# PREVOST

## WARRANTY BULLETIN

**WB15-46**

DATE :	OCTOBER 2015	SECTION :	18 - BODY
EXPIRATION:	OCTOBER 2017		
SUBJECT :	EPA Emission Control Decal Replacement

FIG.1 CORRECT INFORMATION ON NEW EPA DECAL – CANADIAN BUILT VEHICLE SHOWN

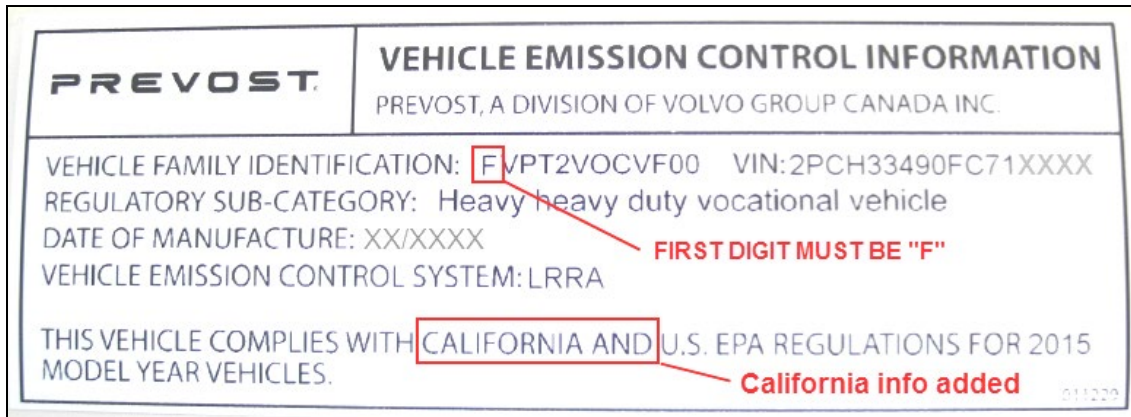
On the vehicles affected by this bulletin the EPA (US Environment Protection Agency) decal located in the engine compartment displays incorrect information related to the vehicle emission control.

Specifically, the first character, indicating the model year in the vehicle family identification number is incorrect and the California state EPA compliance notice is missing.

1. Validate that the new EPA decal information is correct:
  - Vehicle family Identification number first digit must be "F" (see Fig.1).
  - Regulation compliance must include California (see Fig.1).
  - Vehicle VIN must match VIN on the new decal (see Fig 2).
2. Remove the vehicle EPA decal located in the engine compartment (see Fig.3). Do not install the new decal over the old one.
3. Carefully clean the decal area from all traces of dirt, road grime and old adhesive.
4. Reinstall the new decal at the same location on the vehicle, make sure of proper adhesion.
